**SITE PLAN REVIEW SHEET
ENVIRONMENTAL VARIANCE REQUEST ONLY**

CASE: SP-2021-0091C

PROJECT NAME: Oltorf Site Plan

**Variance Requests from LDC 25-8-301, LDC 25-8-341 and LDC 25-8-342
Associated with SP-2021-0091C, 4544 E Oltorf**

CUT/FILL EXHIBIT

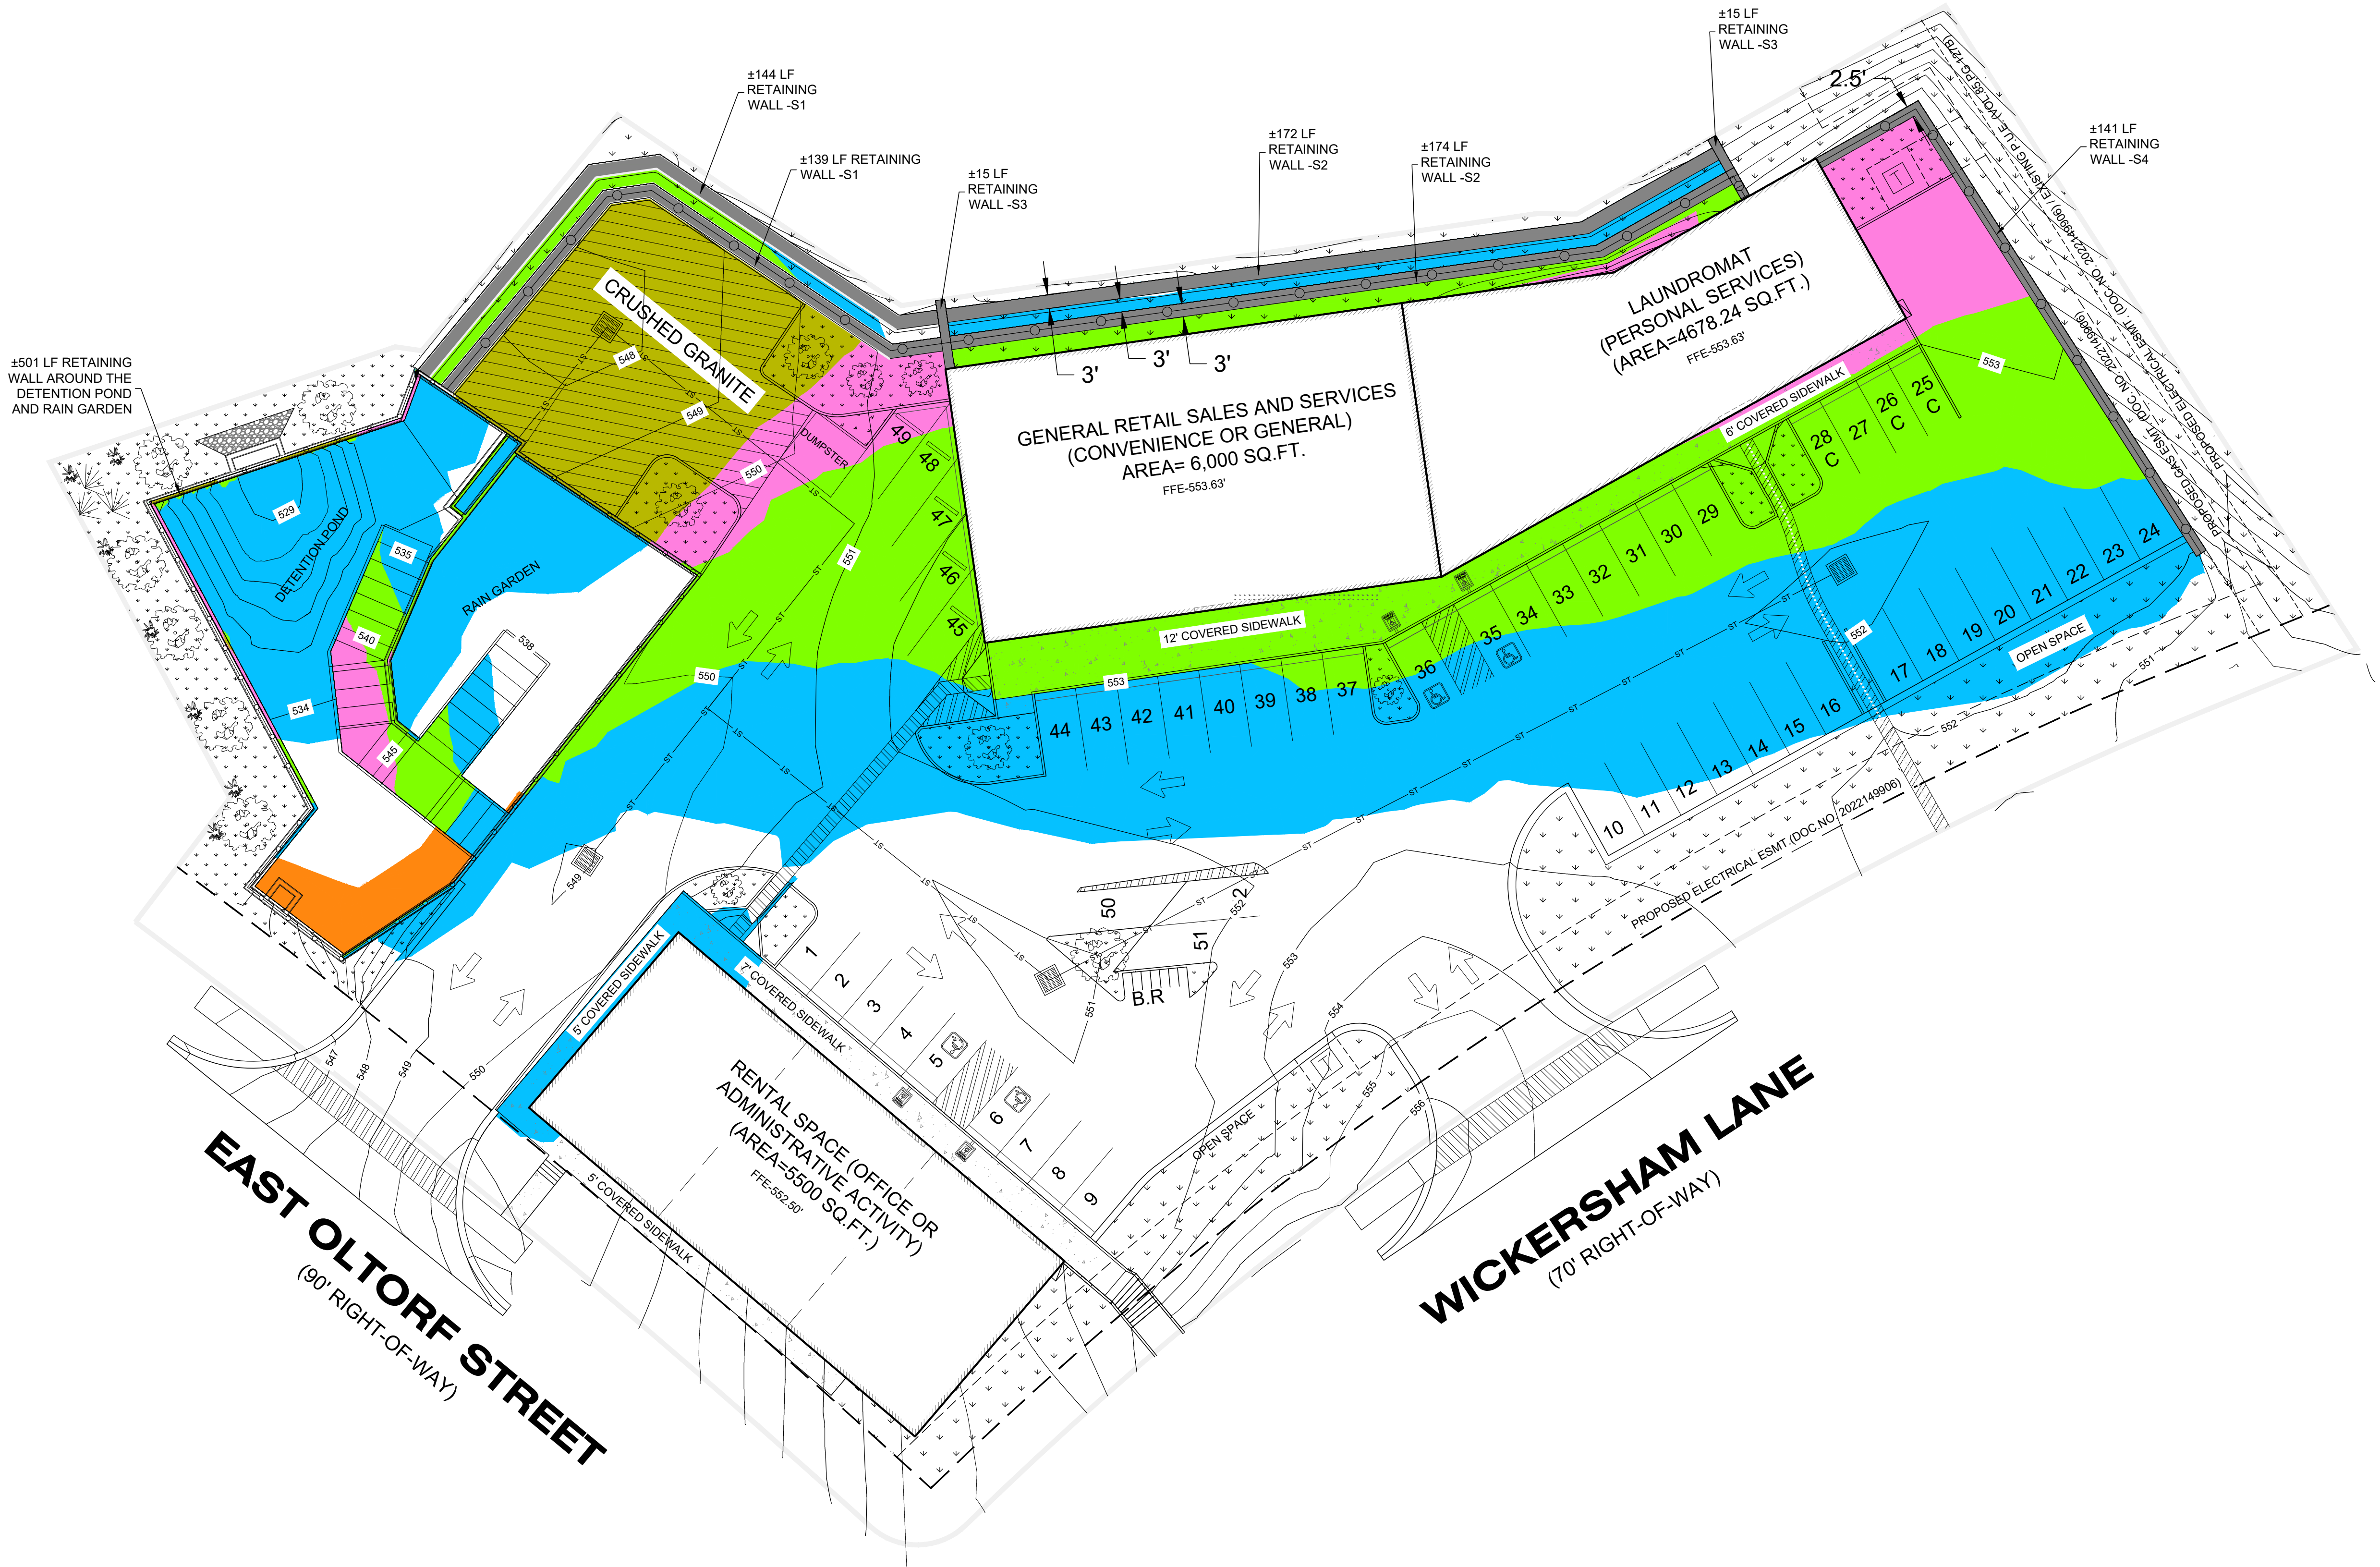
In order to facilitate this type of drainage which will require stormwater releases from detention ponds to flow into the storm sewer pipes along East Oltorf, grading within the detention/water quality area will have cut up to 8 feet and fill up to 20.5 feet.

Yes. The variance does not create a significant probability of harmful environmental consequences. The variance is a minimum deviation from code to allow for reasonable use of the property. Fill will be minimized and structurally contained with retaining walls.

- Provide 8 additional trees at 3 caliper inches.
- Provide structural containment of fill with retaining walls.
